Village of Arlington Heights
Plan Commission
Board Room
Arlington Heights Village Hall
33 S. Arlington Heights Road
Arlington Heights, IL 60005
September 30, 2015
7:30 PM

- A. The Moorings - 811 E. Central Rd. - PC#15-012
PUD Amendment
- B. Collision Damage Experts - 9 E. College Dr. - PC#15-018
Land Use Variation

VOLUME I CIVIL DRAWING NO.: 2014104 COMMISSION NO.: 2014104		RENDERING DATE: 06/26/2015 SCALE: AS NOTED		REVISIONS NO. DATE DESCRIPTION		FOR THE MOORINGS OF ARLINGTON HEIGHTS PRESBYTERIAN HOMES 811 EAST CENTRAL ROAD, ARLINGTON HEIGHTS, IL 60005 DRAWN BY: J.S.D. COORDINATED BY: C.S.L. CHECKED BY: J.F.H. APPROVED BY: C.P.K.		rtps architects® architecture • master planning • interior design 250 VALLEYBROOK DRIVE, LANCASTER, PA 17601 717-560-9501 FAX: 717-560-2373 RLPS, LLP		PLANNING COMMISSION SUBMISSION	THIS DRAWING IS AN INSTRUMENT OF SERVICE. IT IS THE PROPERTY OF RLPS ARCHITECTS, P.C. AND IS NOT TO BE REPRODUCED WITHOUT THE ARCHITECT'S PERMISSION AND UNLESS IT BEARS THE NAME OF THE ARCHITECT. CONTRACTOR SHALL VERIFY ALL DIMENSIONS AND CONDITIONS AT THE SITE BEFORE PROCEEDING WITH THE WORK.	
--	--	--	--	-----------------------------------	--	--	--	--	--	----------------

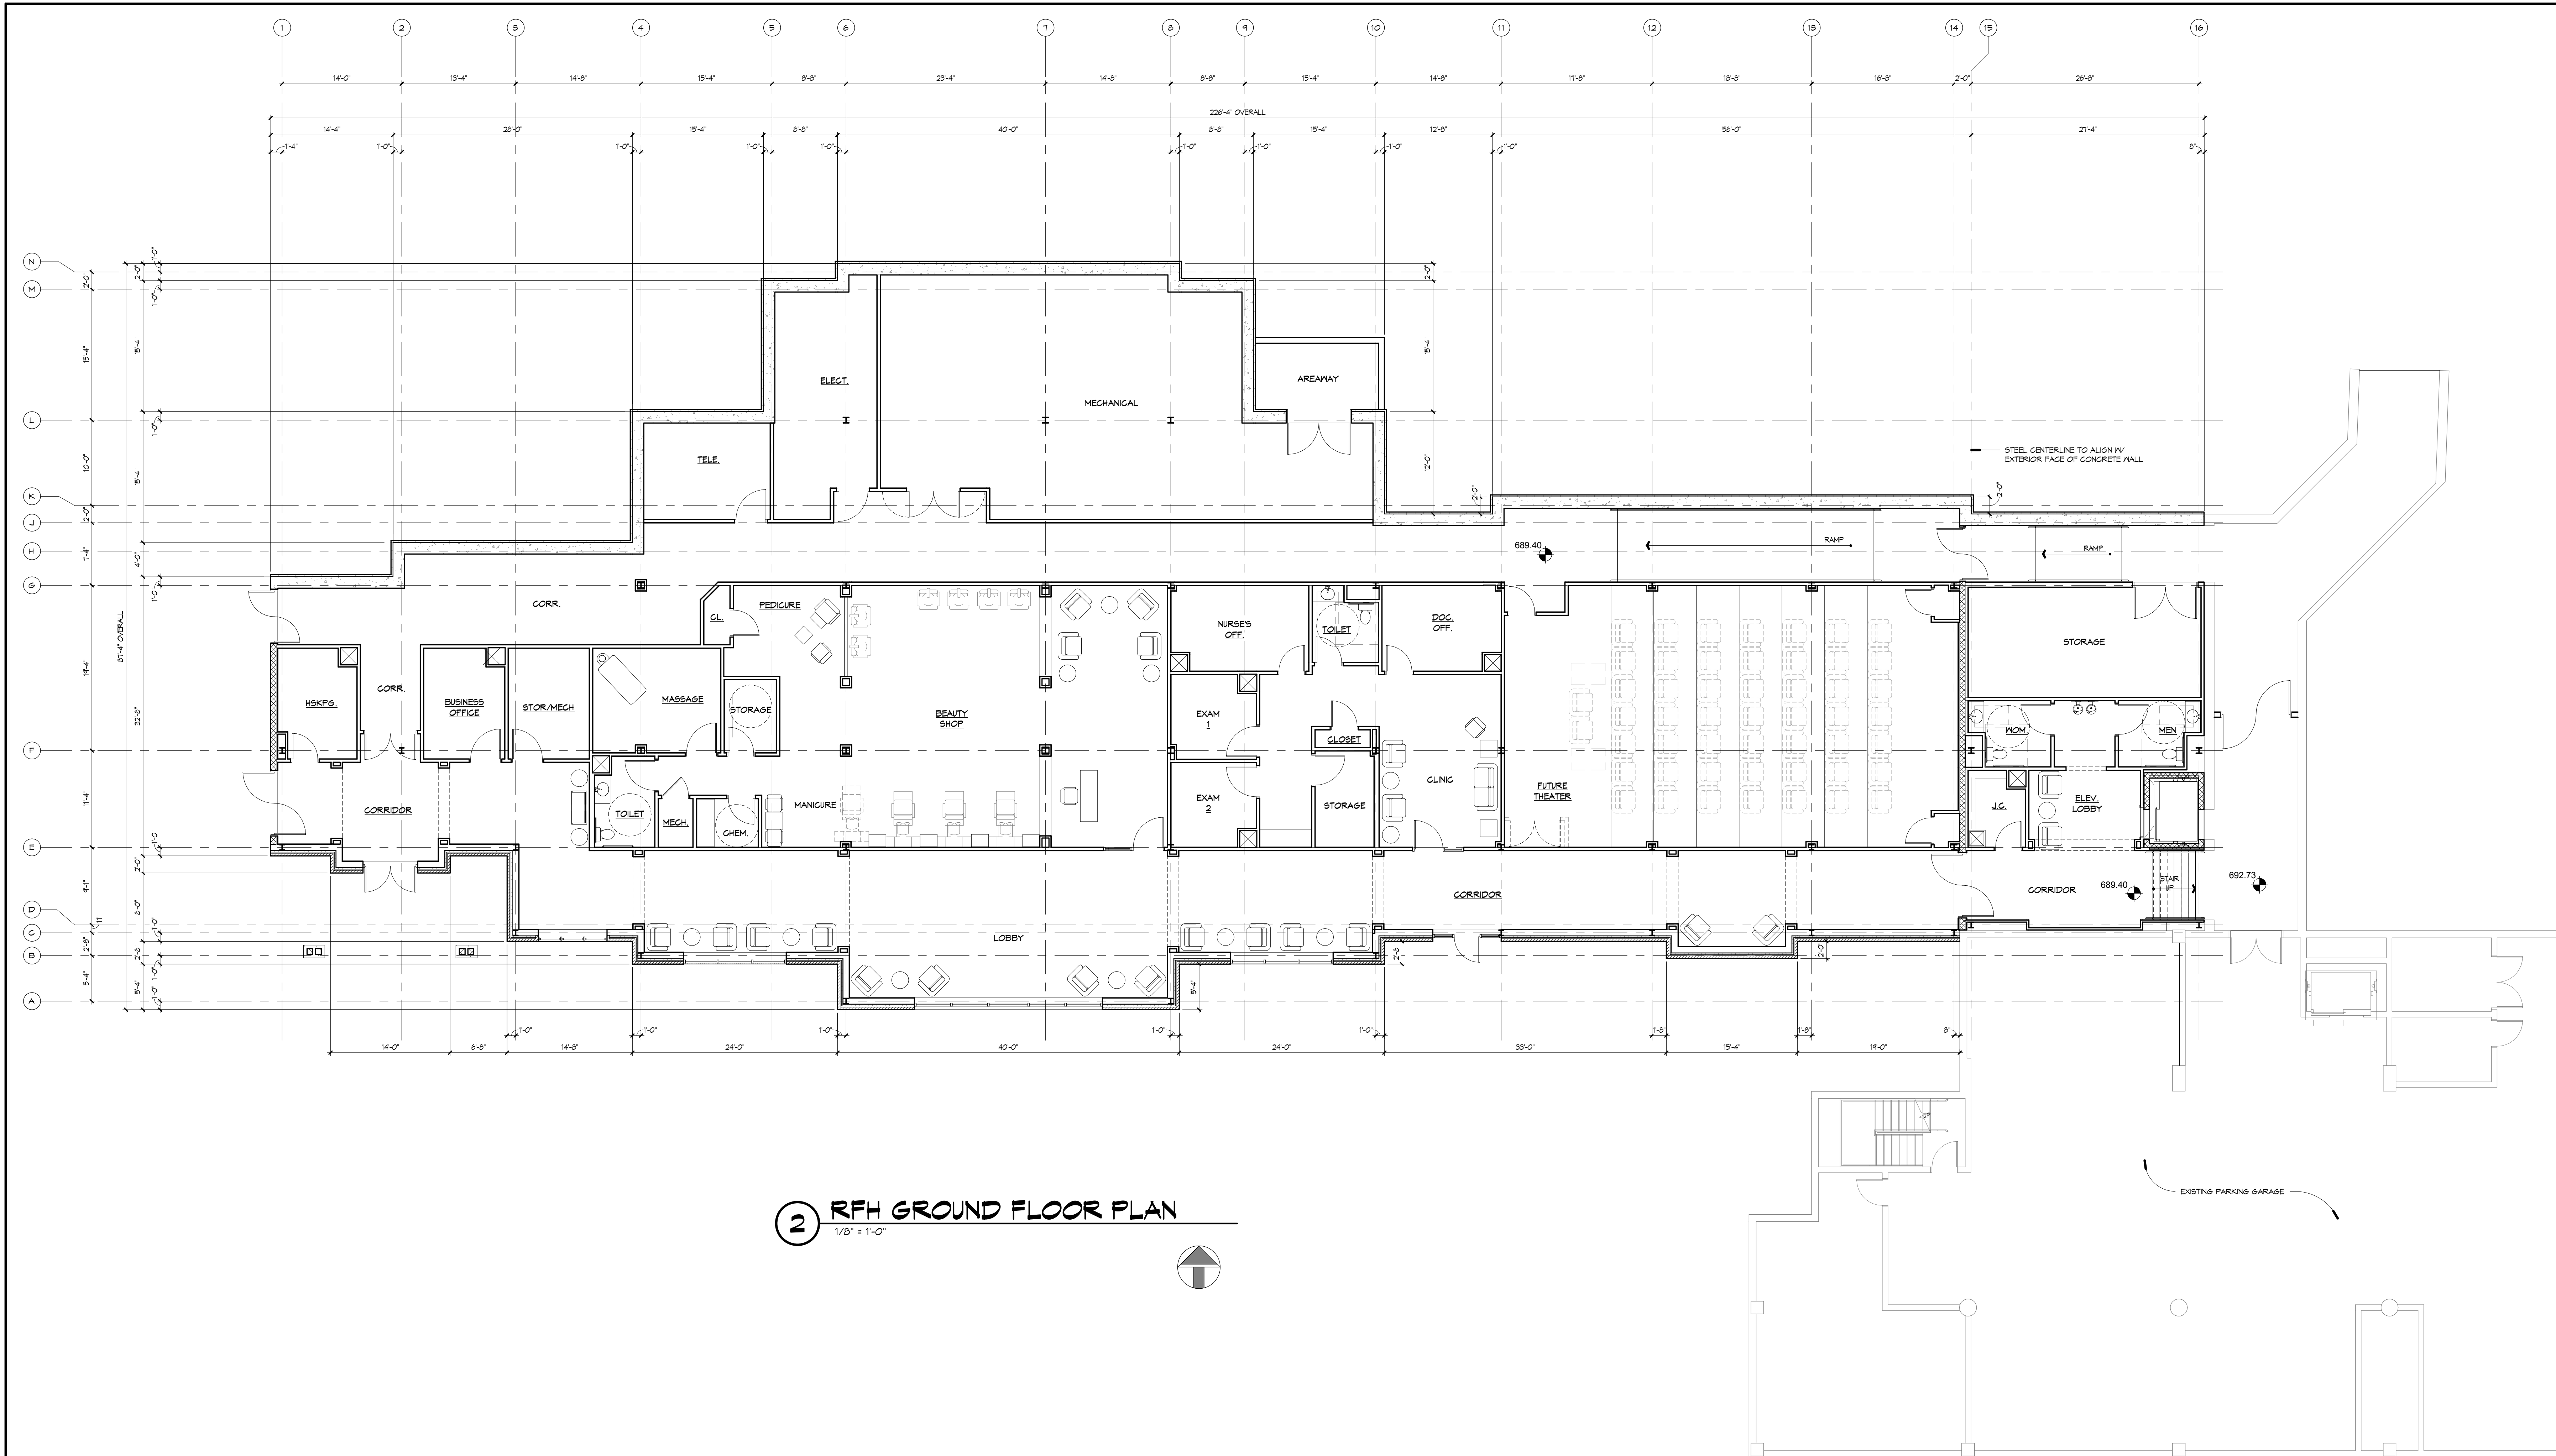
Sheet A101

3. In the Men's and Women's Locker Rooms the wheelchair accessible "Standard Stall" door shall open opposite the clear floor space to allow adequate wheelchair maneuvering space within the stall, per IAC Section 400.Illustration B. Figure 30(a).

1. The plans have been modified to to provide required clearance. See attached Resident Fellowship Hall drawing A101.
2. The stalls have been modified to provide required clearances. See attached Resident Fellowship Hall drawing A102.
3. The stalls have been modified to provide required clearances. See attached Assisted Living drawing A101.

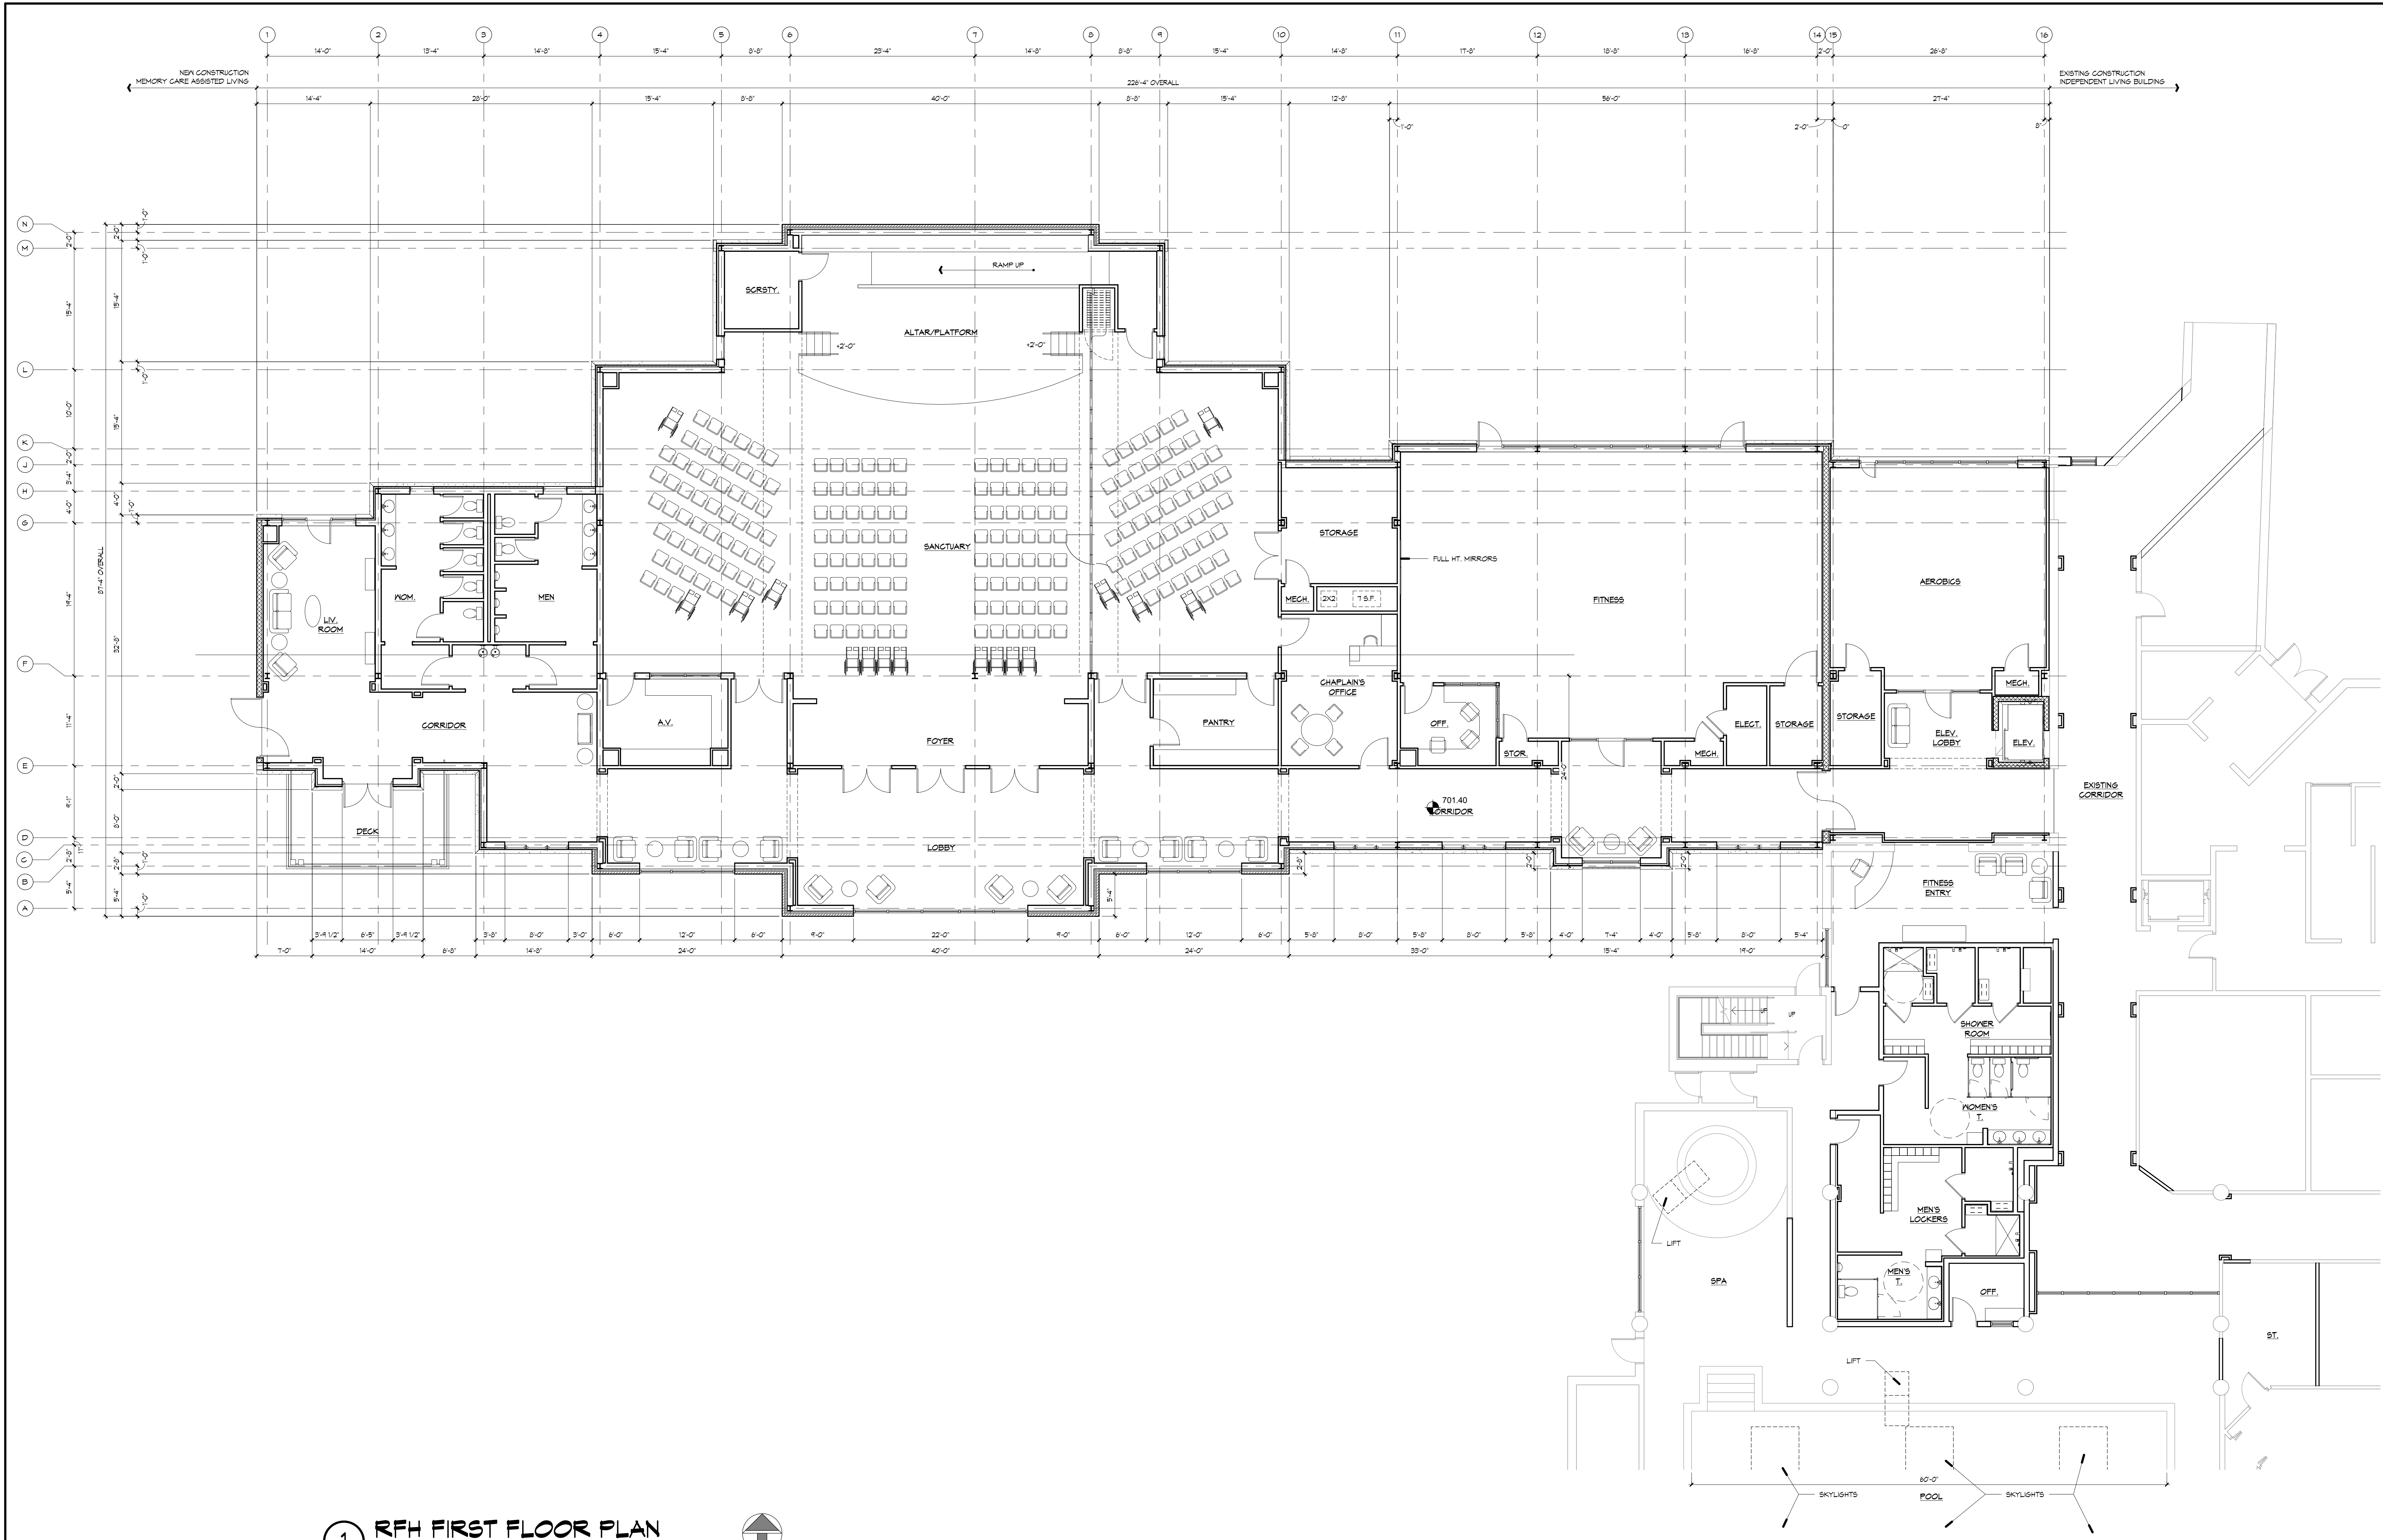
Sheet A102

2. In the Men's and Women's Toilet Rooms the wheelchair accessible "Standard Stall" door shall open opposite the clear floor space to allow adequate wheelchair maneuvering space within the stall, per IAC Section 400.Illustration B. Figure 30(a).
